### **T312 Veteran Oak**

## 2.15-2.20 Conclusion

Sketch and scale pasted at same magnification

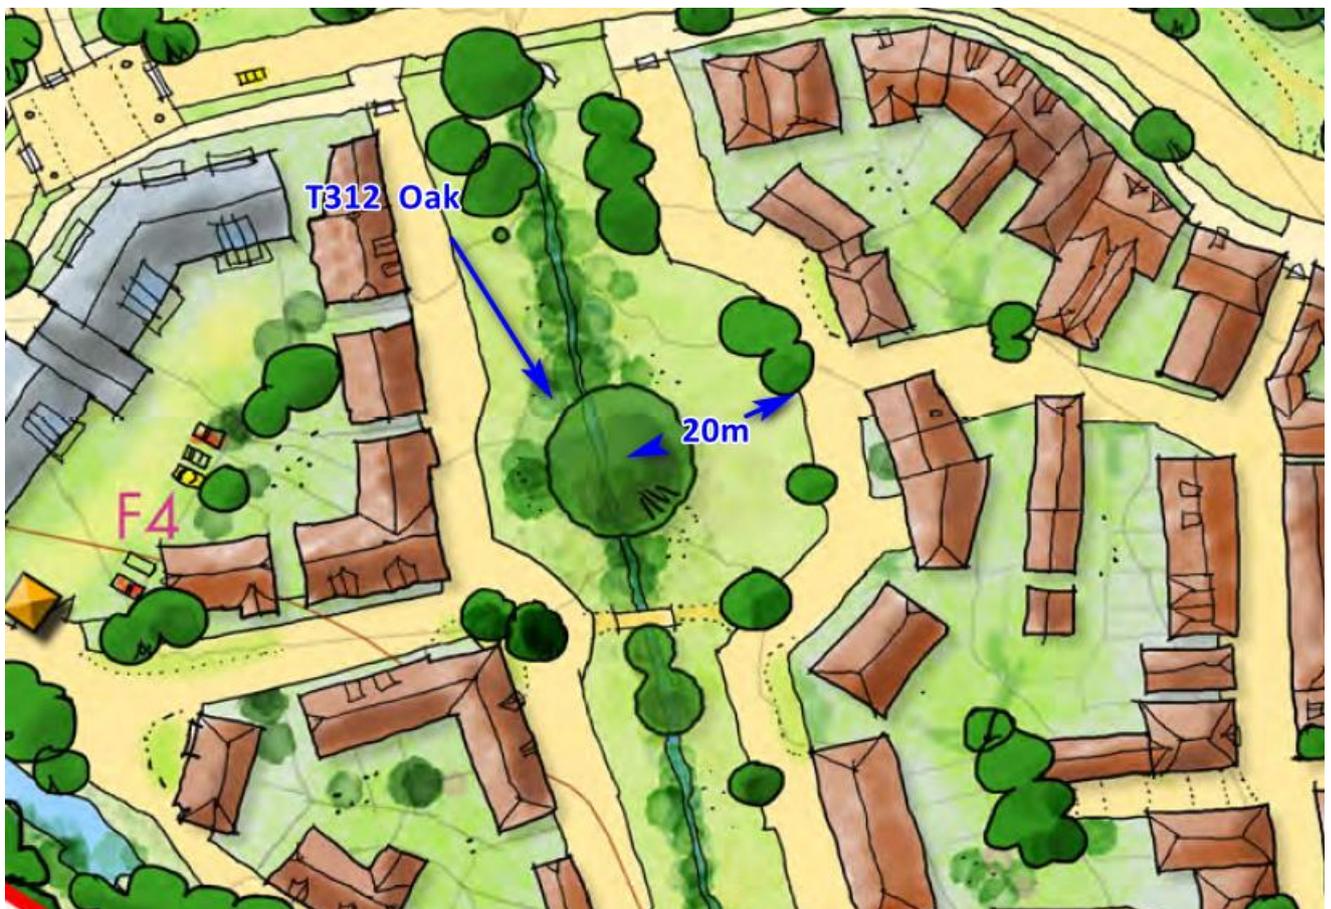
**2.9** The minimum 5m clearance from the edge of the crown is described as being exceeded with the morphing of the buffer zone, this is accepted as reasonable if the morphing occurs, but given the scale of the area<sup>2</sup> of the buffer zone and it being displaced from one side, in the Landscape Officer's (LO) view the buffer area from the edge of the crown should be maximised. In any event, it should be noted that the NESA states that the buffer zone of a veteran tree should be *at least* 15 times larger than the diameter of the tree and it follows that a more generous buffer zone should be widespread in practice than it is.

**2.10-2.14** The purpose of the RPA and Buffer Zones is set out by SJA and the principle of morphing the buffer zones is accepted by the LO subject to a further evidential base. However, the ultimate shape of the buffer zone is a matter for discussion. The approach to setting the buffer zone into the hedge owing to the benefit of the semi-natural habitat is reasonable but it does not maximise the 'buffer' element of the buffer zone. The Landscape Officer justifies an approach that largely maximises the buffer area with the grassland area incorporated for the following reasons:

5. In cultural and amenity terms, the context of a tree like T312 is extremely important as part of the areas heritage. In order to appreciate the significance of the veteran oak it is desirable for it (and any similar trees within the development) to have enough space around them to enable the appreciation of such natural assets and a maximised buffer zone will assist in achieving this in tandem with good design. The illustrative masterplan (Rumney 31 07 2019) appears to embody such an approach in terms of the landscape function of the tree, notwithstanding the illustrative nature of the sketch, the space afforded to the buffer zone and any fringe of amenity land does not appear at all sufficient at approximately 20m from the nominal centre of the tree.

For the reasons above, in response to SJA paras 2.10-2.14 the LO would seek a buffer zone that is not morphed into the hedge line and takes an approach that will ultimately maximise the semi-natural habitat (including grassland) within the buffer zone.
